**Subject:** Westpoint - two questions and drawing comments

# DRAFT PHASE I LANDSCAPE CONCEPT WESTPOINT HARBOR REDWOOD CITY, CALIFORNIA

Comments by Ellen Miramontes  
10.19.11

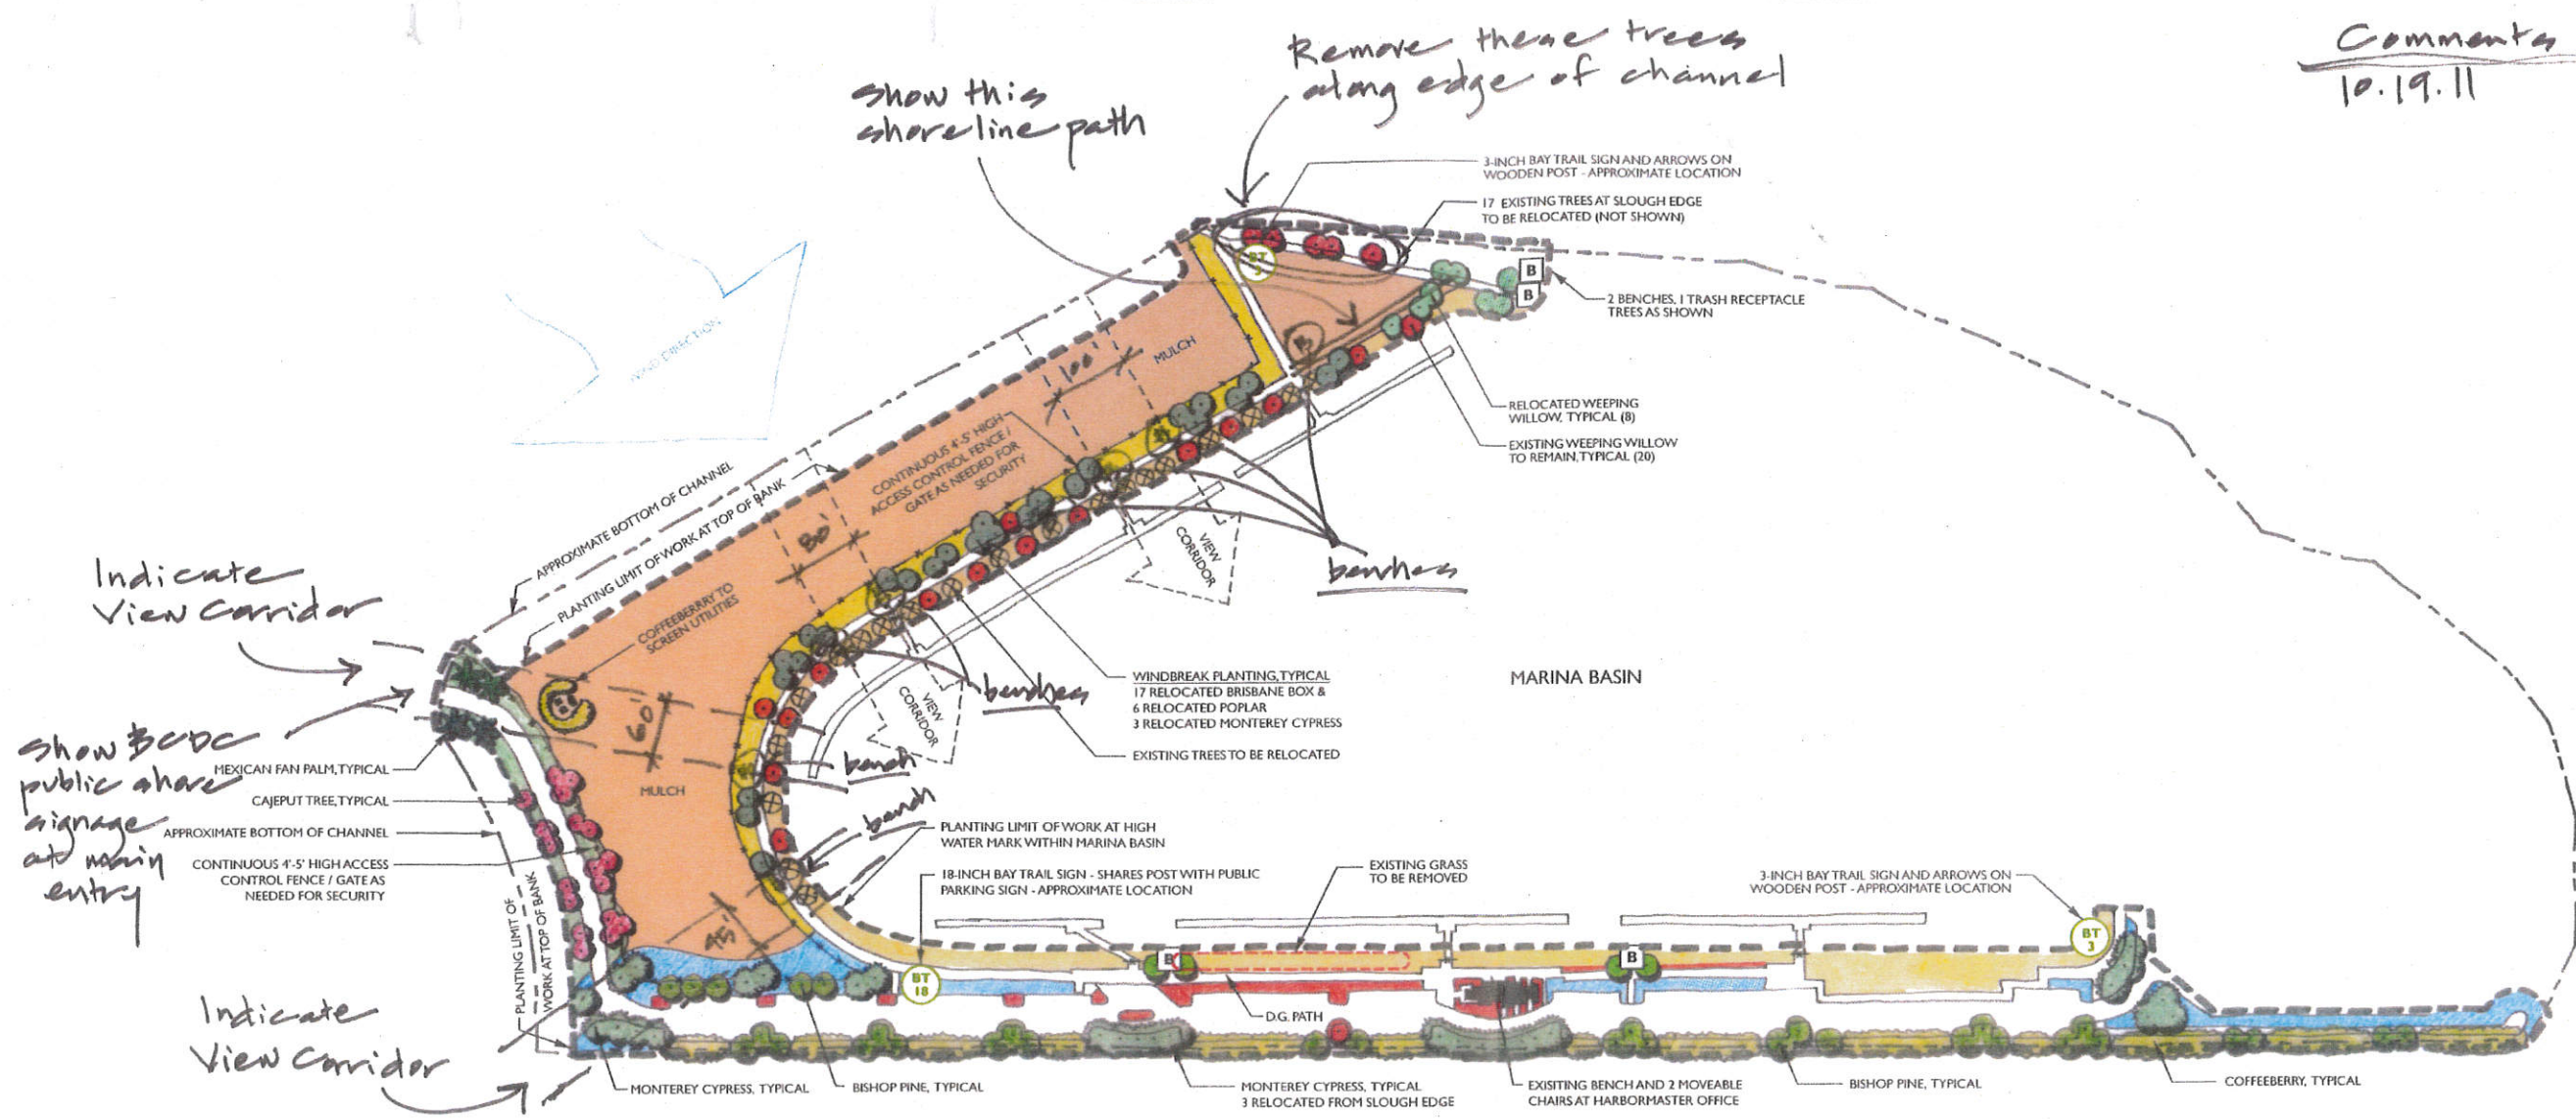
Recommend adding more shrub types in case coffeeberry does not do well; could mix 2 or 3 shrub types for variety and to ensure viability
